AENC-NG-CNS-REP-0208

Norwich to Tilbury

Document: 8.1 Errata List

Final Issue B

Image A14.4.1

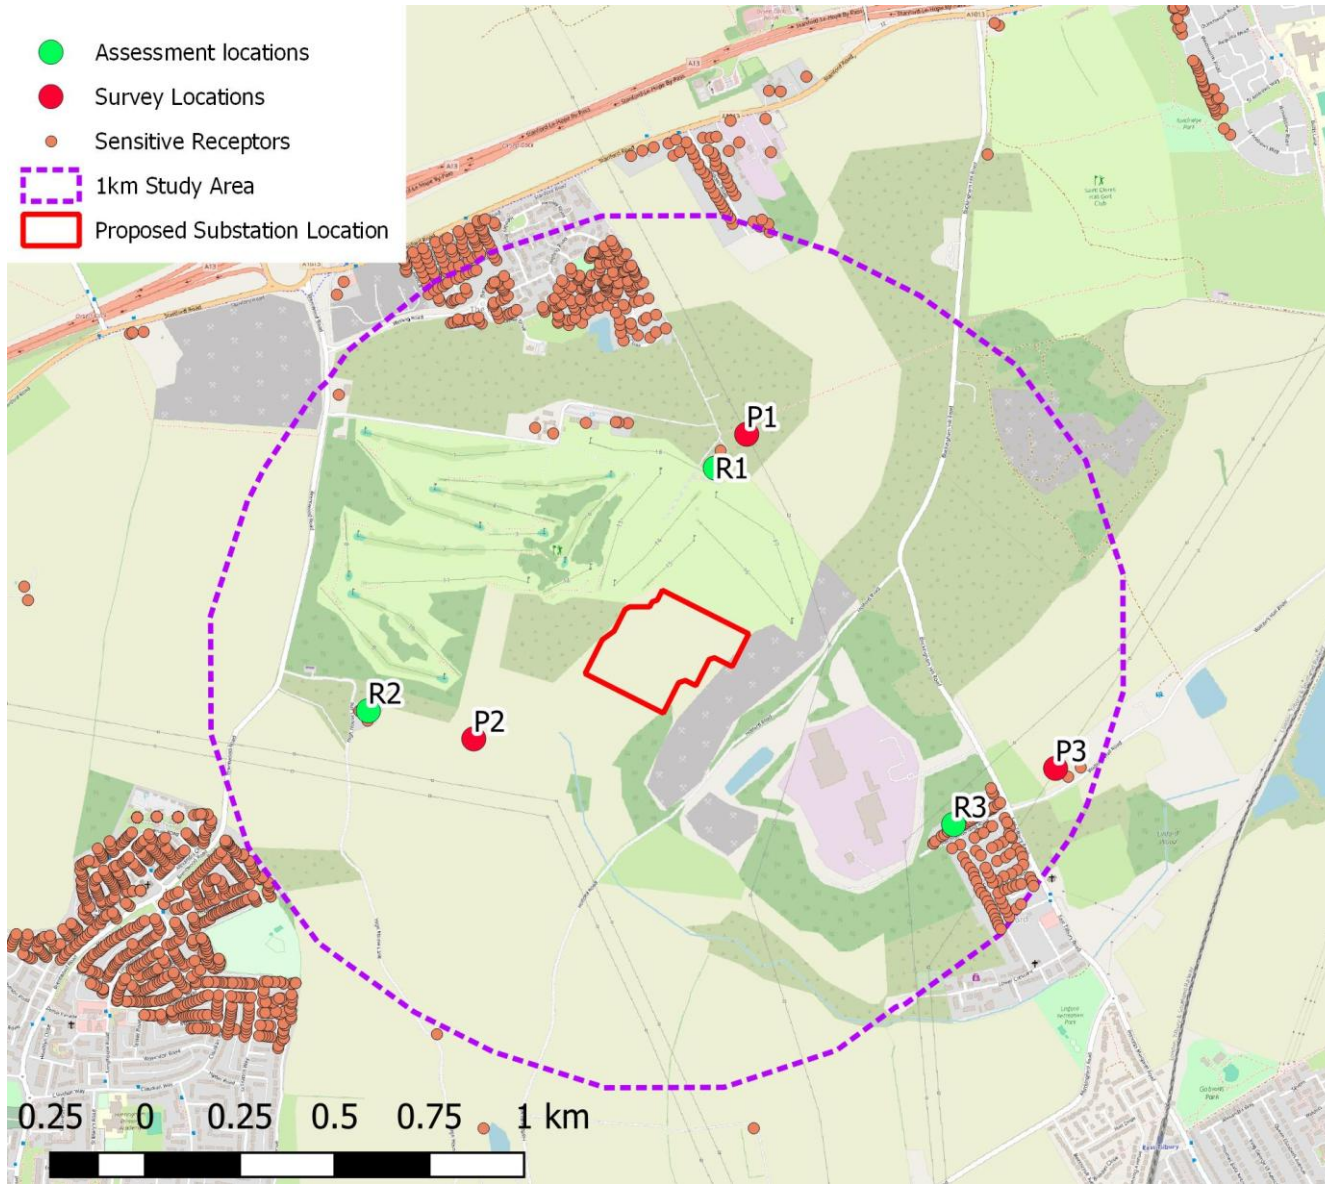
Document Number	Document Name	Paragraph Section Reference	Nature of Erratum	Remedial Text, Reference or Narrative
APP-260	6.14.A4 Environmental Statement Appendix 14.4 - Tilbury North Substation Operational Noise Assessment	Image A14.4.1, Page 4	Correction to labelling of assessment location.	Image A14.4.1 - Operational Noise Baseline Information has been updated and is replaced by Image A14.4.1 - Operational Noise Baseline Information (Rev B) in Appendix C of this Errata. <i>This correction does not alter the conclusions reported in 6.14 Environmental Statement Chapter 14 – Noise and Vibration [APP-256]. This errata is included following a request from Examining Authority in NV 1.14 [REP3-074] at Deadline 3.</i>
APP-265	6.15 Environmental Statement Chapter 15 - Socio-economics Recreation and Tourism	Table 15.26, Page 110 (row referring to Planning applications within Mid Suffolk (Section B))	Correction of planning applications not likely to overlap with the Project's construction programme reported	<i>'There are 16 planning applications have been identified within the Order Limits, twothree of which are not likely to overlap with the Project's construction programme.'</i> <i>'The 4413 planning applications with the potential to overlap with the Project's construction programme are as follows:...</i> <i>This correction does not alter the conclusions reported in 6.15 Environmental Statement Chapter 15 - Socio-economics Recreation and Tourism [APP-265]. This errata is included following a request from Examining Authority in SET 1.12 [REP3-074] at Deadline 3.</i>
